Supplemental Specifications to The Standard Specifications for Road and Bridge Construction, 2000 Edition (Effective with the September 26, 2003 Letting)

RUMBLE STRIP DIMENSIONS

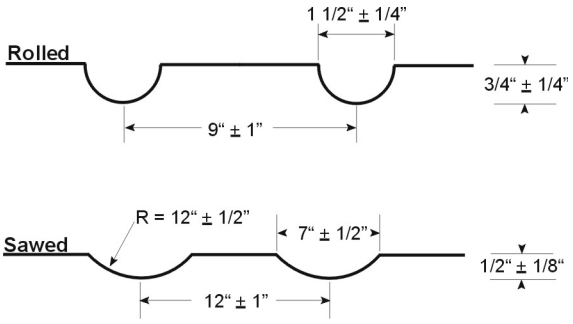
SUBSECTION: 403.03.08 Rumble Strips.
REVISION: Replace with the following:

A) Interstates and Parkways. Construct sawed rumble strips on all mainline and ramp shoulders to the dimensions shown below.

B) Other Roads. When using a surface mixture instead of Asphalt Mixture for Pavement Wedge, or when the Engineer deems it appropriate to pave the driving lanes and the adjacent shoulder monolithically, provide rolled rumble strips. Construct strips on all main line shoulders to the dimensions shown below. When furnishing Asphalt Mixture for Pavement Wedge, binder, or a base mixture for shoulders, the Department will not require rumble strips.

Distance from the edge of the mainline pavement to the end of the strip: 1 foot
Length of strips: Rolled 2 feet, Sawed 16 inches
